SUBJECT: Responds to Insp Rept 50-397/91-27 & delineates program & schedule for resolving issues identified in rept, per 910828 & 29 meetings w/NRC. Program developed to create new EOPs & plant-specific technical guidelines will be reviewed.

Subject: NUCLEAR PLANT NO. 2, OPERATING LICENSE NPF-21
NRC INSPECTION OF WNP-2 EMERGENCY OPERATING PROCEDURES
(NRC INSPECTION REPORT NO. 91-27)

This letter provides the Supply System's response to NRC Inspection Report 50-397/91-27 covering our Emergency Operating Procedure technical development.

0. DESIGN DEVIATION #17

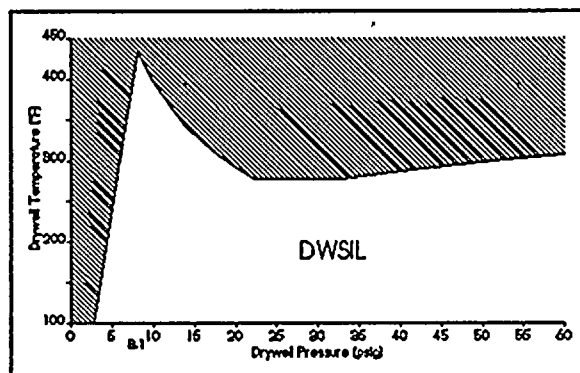
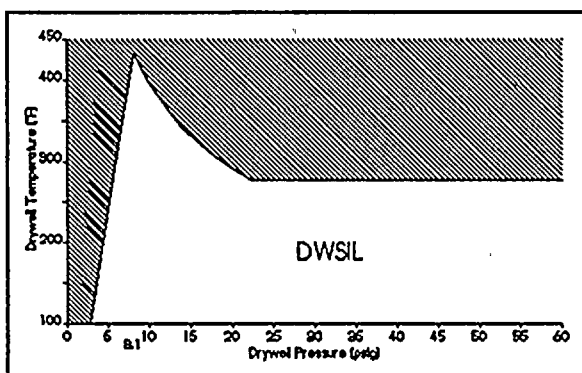
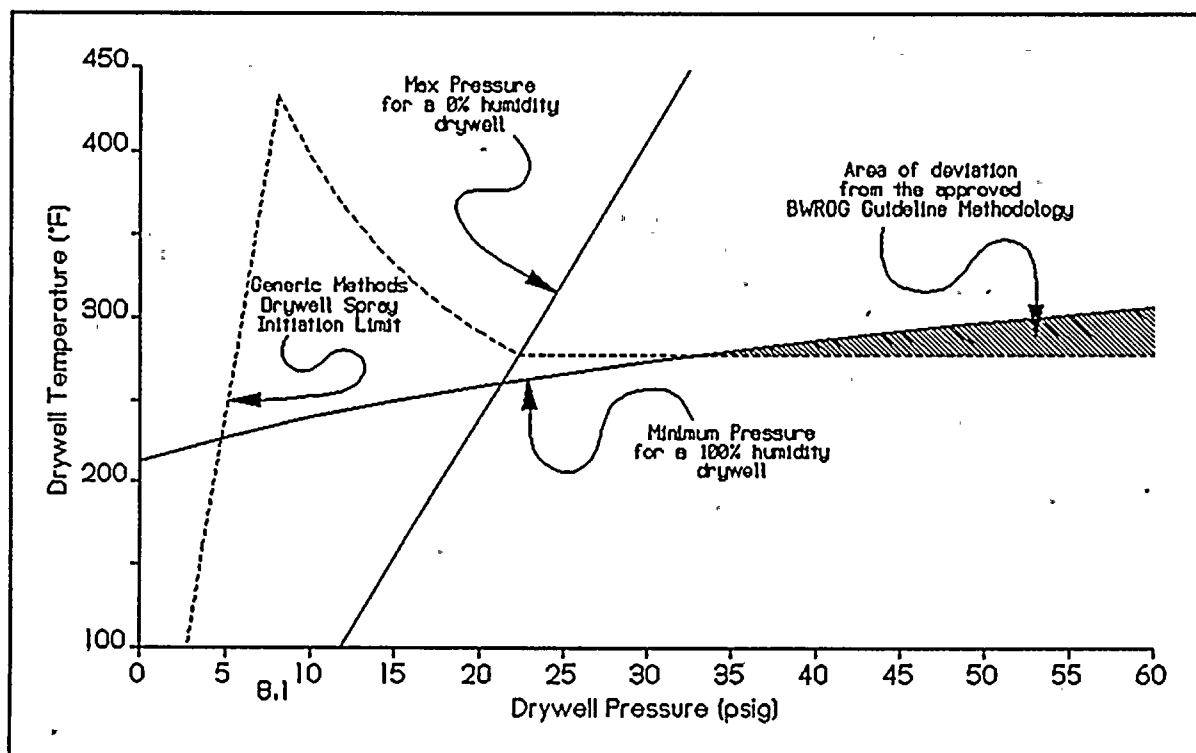
The BWROG EPG Appendix C Drywell Spray Initiation Limit worksheet (WS-3) resulted in a curve for WNP-2 which prevents the use of drywell sprays when the WNP-2 licensing basis assumes they will be used. The DWSIL calculation was slightly modified to allow the use of drywell sprays in saturated drywell atmosphere conditions at high pressures.

No adverse comments. There was considerable discussion with the NRC on this topic. The primary thrust of the discussion was to clarify both the EPG basis for the curve as well as the Supply System's deviation to the curve to accommodate its drywell-to-wetwell bypass leakage event. The NRC indicated they would contact the Supply System if they had further questions on this deviation. No such contact has been made.

The figure below shows these two curves as well as the DWSIL which is developed from the generic guidelines. On the right side of the curve is an area where the water vapor saturation line is above the DWSIL. This is also the region where WNP-2 licensing basis calculations have assumed that the containment sprays would be used in a LOCA type accident.
